**Re:** Ringsend to City Centre Core Bus Corridor Scheme.  
Ringsend to City Centre, Co. Dublin.

**Written Submission from Dublin City  
Council Chief Executive  
to An Bord Pleanála  
in relation to  
the National Transport Authority's  
BusConnects Dublin – Ringsend to City Centre Core Bus Corridor Scheme  
An Bord Pleanála Ref. 317679-23**

Figure 3. Spencer Dock bridges in 1913. Note the appearance of the pair of bridges as a single structure, reinforced by the central control cabin (Now removed).

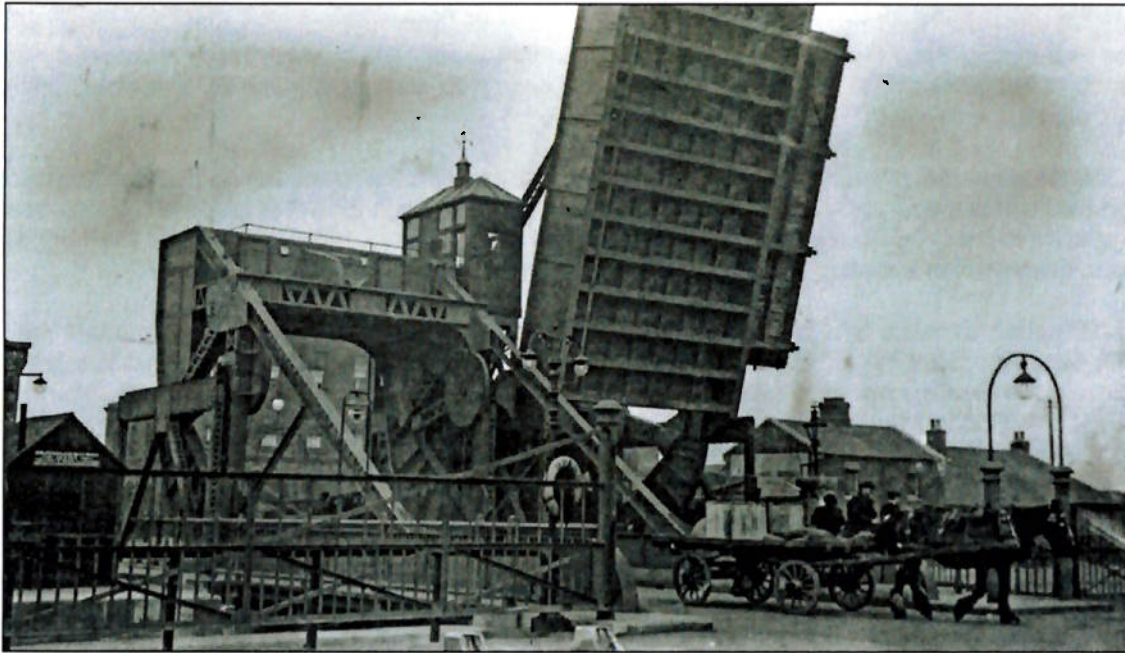
The justification for a four lane road at this location is not fully clear in the EIAR. The Industrial Heritage and Options Appraisal Report states that *'it is assumed that the case for two dedicated bus lanes in addition to the existing two-lane carriageway has been made elsewhere to meet the requirements of BusConnects Dublin along CBC route 16.'* The heritage opinion appears to have been made after route design decisions have been made rather than informing the design phase.

To conclude, the Proposed Scheme will have a permanent impact on the Scherzer Bridges resulting in the loss of original fabric, of the original paired form and special character of the original setting. It is recommended by this office that further and more detailed research be done by the NTA into revised design options to allow the bridges to remain in situ. After which should permanent impact on the bridges be found necessary for the Proposed Scheme it should be demonstrated that the decision is based upon the economic and social positives of the scheme and clearly stated in the report that there will be a negative architectural heritage impact on the structures which cannot be fully mitigated.

Update the EIAR to contain revised proposals for the Scherzer Bridges and fully evaluate options for retention in situ.

Figure 7. View of North Wall Quay showing section of 'Free Flow' in situ.

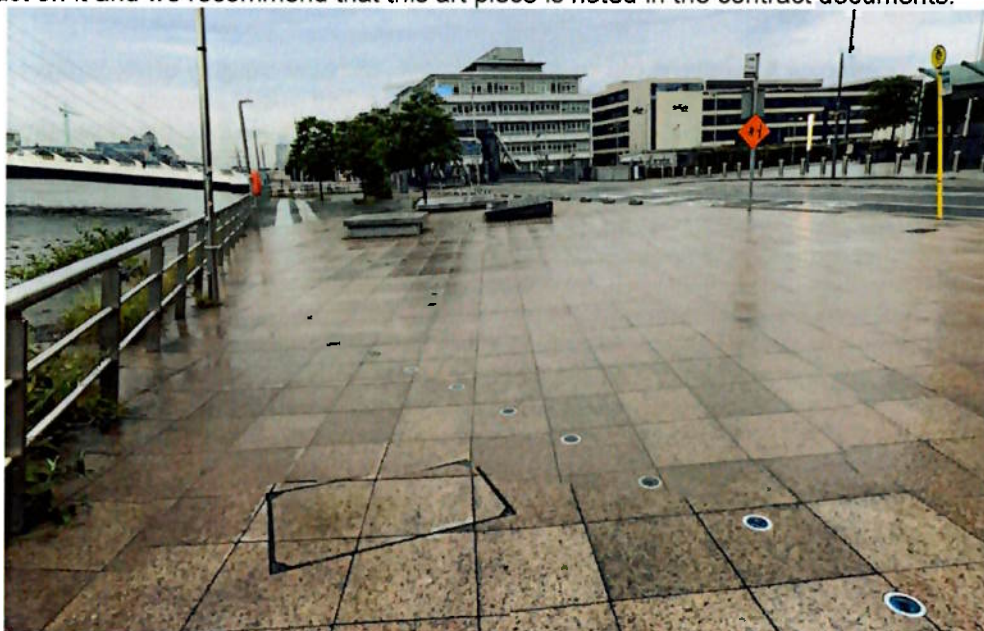
Within the EIAR Cultural Heritage assets have been bundled with archaeology, so that while strictly speaking these assets are outside of the remit of the Archaeology Section, some observations were made that are of wider concern and these points are highlighted here. The EIAR does not assess the impact of the scheme on the artwork *Free Flow* (2005) by Rachel Joynt and the authors may in fact be unaware of it. Commissioned by the Dockland Development Authority, this piece consists of 900 glass cobbles containing silver and copper sea creatures set into light fixtures which run from Customs House Quay to the Point Depot. Rachel Joynt is one of Ireland's most notable public artists, and is responsible for several other pieces in the city including *People's Island* (1988), a series of crisscrossing bronze footprints on the pavement at the south site of O'Connell Bridge, and *Woodkey Walk* (1992), a trail of 18 panels around the perimeter of the Civic Offices showing artefacts discovered during the archaeological excavations on the site. A more recent high profile commission was *Dearcán na nDaoine – The People's Acorn* (2017), installed on the grounds of Áras an Uachtaráin as part of the 1916 centenary commemorations. Due to the understated nature of this linear artwork it is vulnerable to any construction being carried out in the area and an assessment of the potential impact of the scheme should be carried out as a priority, including mapping the location of the individual lights on the scheme documentation. During the construction of the Luas Cross City project in 2017 there was an impact on *People's Island* and the opportunity was taken to work with the artist to restore and reconfigure the artwork to ensure the piece continues to be enjoyed in the future. A similar proposal might be considered here. Archaeological monitoring and recording method and techniques would be useful in mitigating for any impact on it and we recommend that this art piece is noted in the contract documents.
